# Emails

Subject	<b>Cross City Cycling E. Fulbourn Road</b>
From	[REDACTED]
To	City Deal
Sent	04 January 2016 13:22

#### Green end road (Nuffield road to water lane)

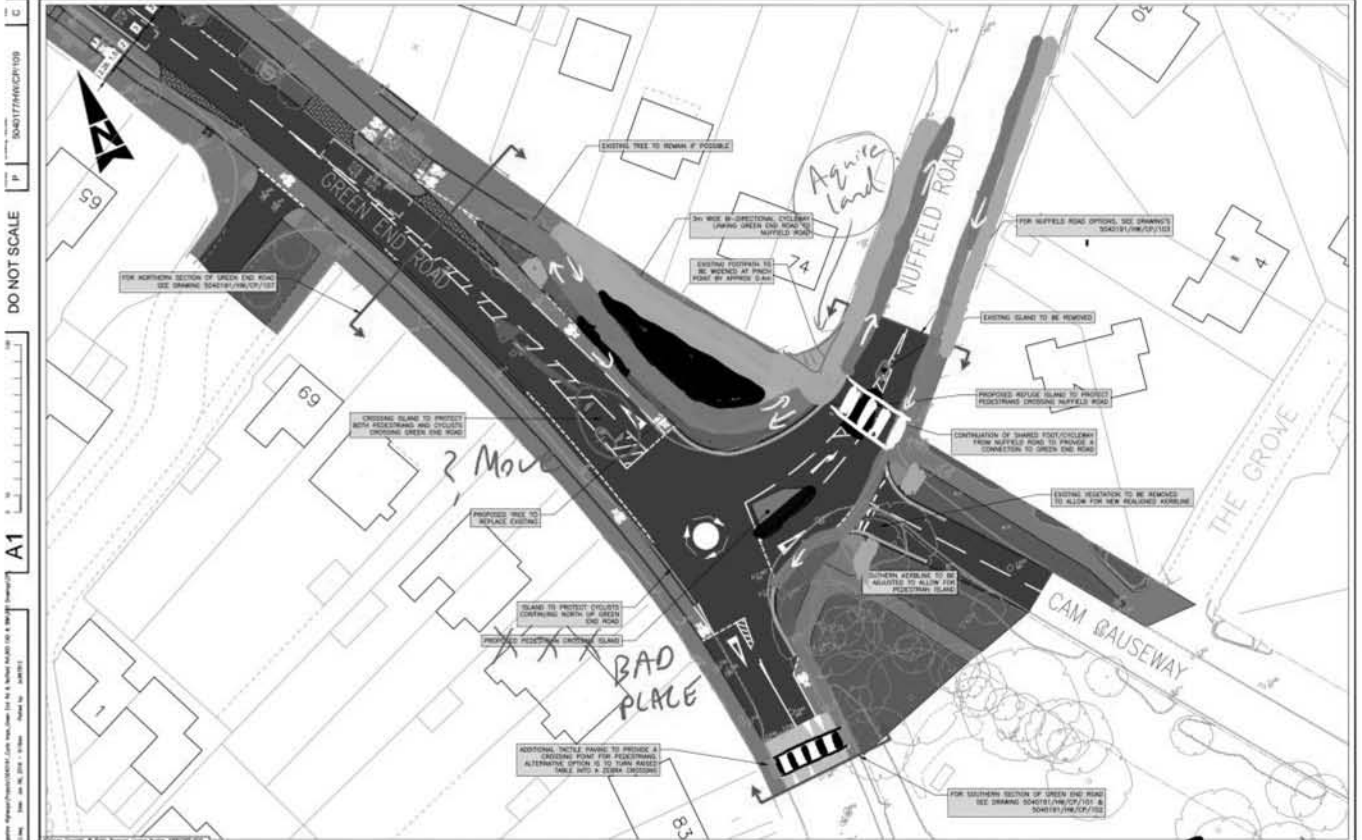
All looks good

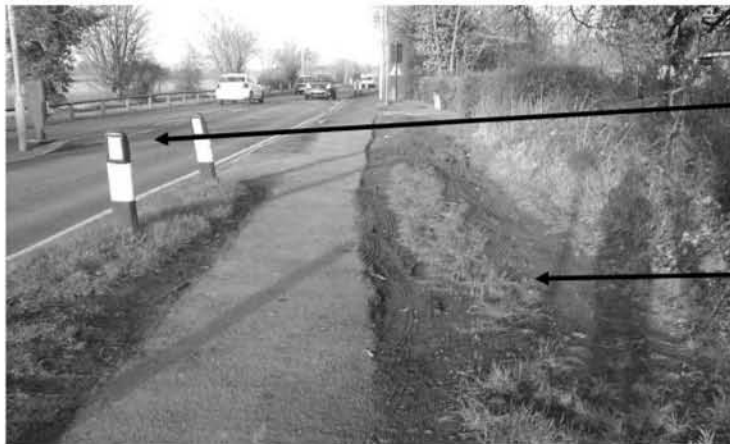
Reinstate damaged grass verges and installation of knee rails in-keeping with existing to protect verges

Proposed site  
new crossing

Examples of timber framed 'open' style bus shelters as replacement to existing.

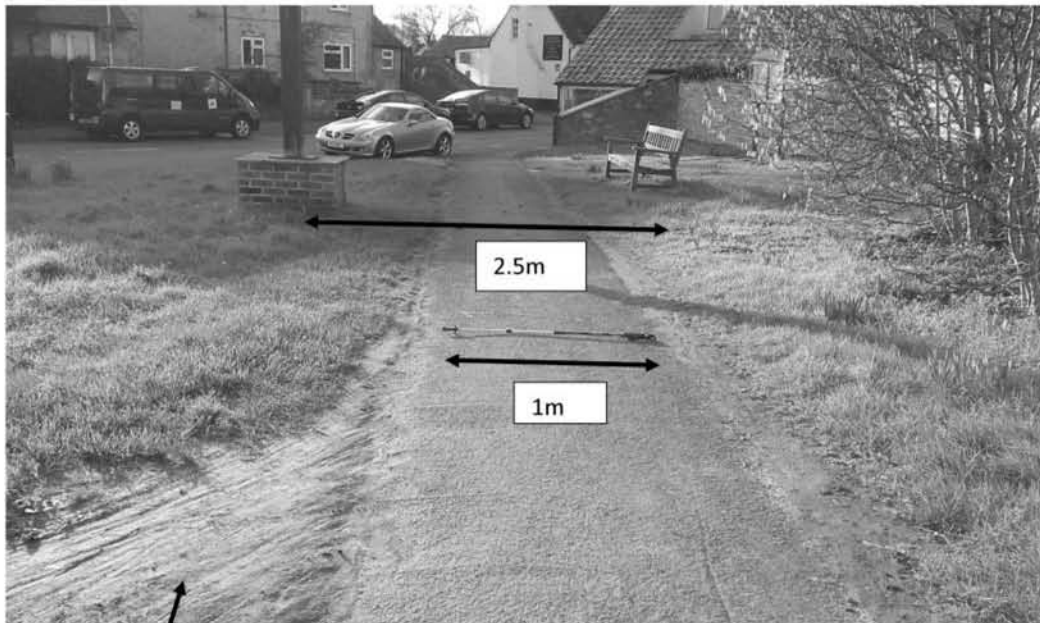
1. Replacement rather than removal of existing Bus Shelter. To replace with an alternative narrower 'open' style design in-keeping with character of Village and sensitive to conservation area ie timber structure not urban design. Requires sufficient roof line for 8 to 10 to benefit from some shelter. Ideally to sit behind or offset to new footpath but, if necessary on it, hence recommendation of a narrow construction.

Narrow base takes limited space on path but limited no's can shelter

Wider base would offer more shelter but take up more space on path.

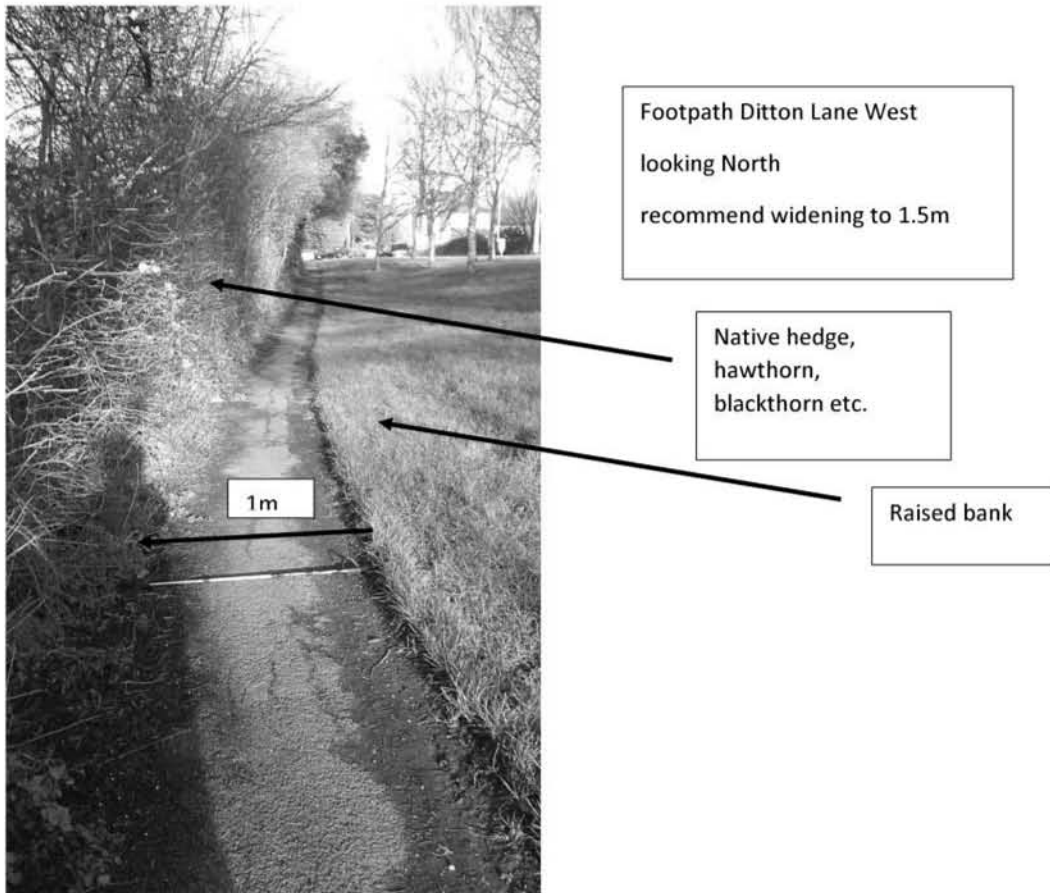
- i) Retain as much of the grass bank and slope as possible
  - ii) Review the feasibility of a retaining wall and or reduction in depth of the bank in the light of containment of the run off from the Paddock and unintended environmental consequences.

- iii) Ensure any engineering works secure the bank in place to prevent erosion and problematic run off/soil deposits on new path and include sufficient replacement top soil to enable sustainable re-planting.

- v) To retain existing Rowan Tress if possible, if not, as proposed to replace the same species on top of the bank.
  - vi) Replacing existing original council concrete post and wire fencing with wooden post and rail fencing as per North side of field to enhance landscape and amenity value.

- vii) If existing Rowan Trees are to be lost and replacement planted on top, a new planting scheme in the grass bank, for example naturalised spring bulbs or strips of wild flowers of value to insects etc., to be incorporated into the scheme.

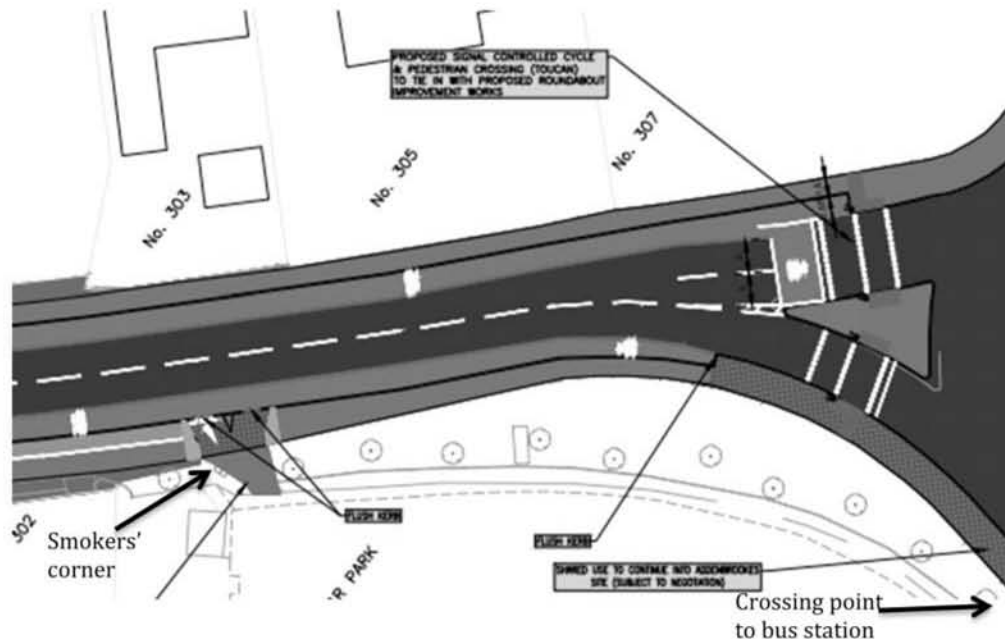
I am also concerned that the scheme will increase conflict between cyclists and **pedestrians**, illustrated by the map on the following page which is an amended version of the drawing on the GCCDP website. As you can see the scheme proposes to encourage cycle movements onto/off the hospital site at two access points: the ramp beside the car park and the pavement beside the roundabout. However, increased cycle throughput at these access points will increase the risk of conflict:

- the ramp beside the car park: as a result of the hospital's policy banning smoking on site, the corner by the ramp has become a congregation point for smokers, complete with bins. Bikes heading south on Hills Road and turning right onto the ramp will be cutting across pedestrians walking south on the footpath. If the option promoting the diagonal crossing and the contraflow cyclepath on the pavement is adopted, these cyclists will also be cutting across pedestrians as they make the right turn. However, I do also wonder what evidence the City Deal team have that, if the diagonal crossing & contraflow option is not adopted, cyclists won't just continue to cycle on the pavement as they currently do?
